From: Eric Duncan ^{ED}
To: ExponentreportGroup
Date: Thu, May 3, 2007 4:01 PM
Subject: UCS Letter to NEIL Concerning Exponent Report

SUBJECT: FIRSTENERGY'S DAVIS-BESSE REPORT

I read your letter dated February 23, 2007, to Mr. Gary R. Leidich at FirstEnergy Nuclear Operating Company (FENOC) regarding the report prepared by Exponent Failure Analysis Associates and Altran Solutions Corporation about reactor vessel head degradation at the Davis-Besse nuclear plant. FENOC submitted the report to the Nuclear Regulatory Commission (NRC), which is available in the NRC's ADAMS online electronic library under ML070860211. I have read the report, too.

Figure 7.2 Three-day average unidentified leak rate for Davis-Besse Cycle 13.⁶⁷

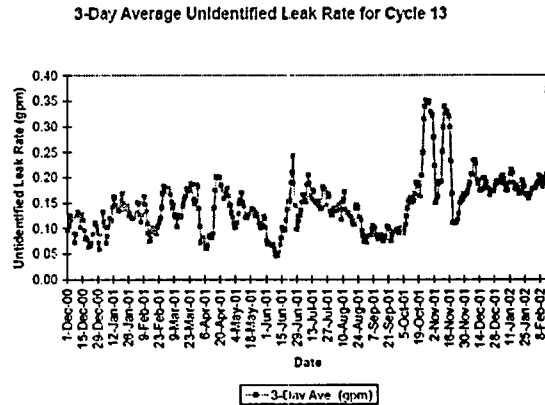
- The Exponent / Altran report relies on circumstantial evidence to support the theory of crack uncovering in the October – November 2001 timeframe. Among the cited evidence is an increase in unidentified leak rate occurring after October 19, 2001. Figure 7.2 from the Exponent / Altran report shows this increase. But the report does not mention or account for the fact that Davis-Besse was shut down on October 19, 2001, and restarted less than a day later due to a generator stator cooling water problem. The thermal cycling associated with shutting down and restarting a nuclear power plant could easily explain a discernible yet minor increase in the unidentified leakage rate.

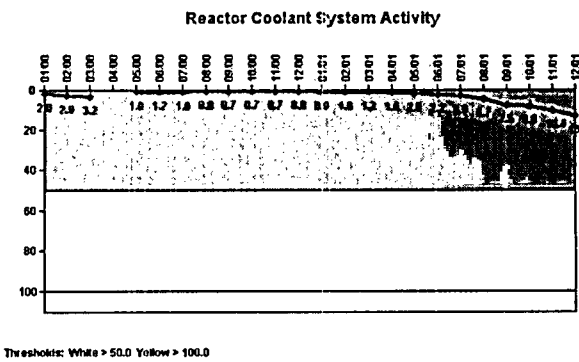
- Leakage of borated reactor coolant water resulting in the accumulation of boric acid crystals on the carbon steel reactor vessels was identified at US reactors other than Davis-Besse, including Oconee, Sequoyah, and South Texas Project (shown in picture). Only Davis-Besse encountered significant corrosion and wastage of the head. If the fast corrosion rate theory were close to reality, evidence of corrosion / wastage should have been identified at these other reactors, too.
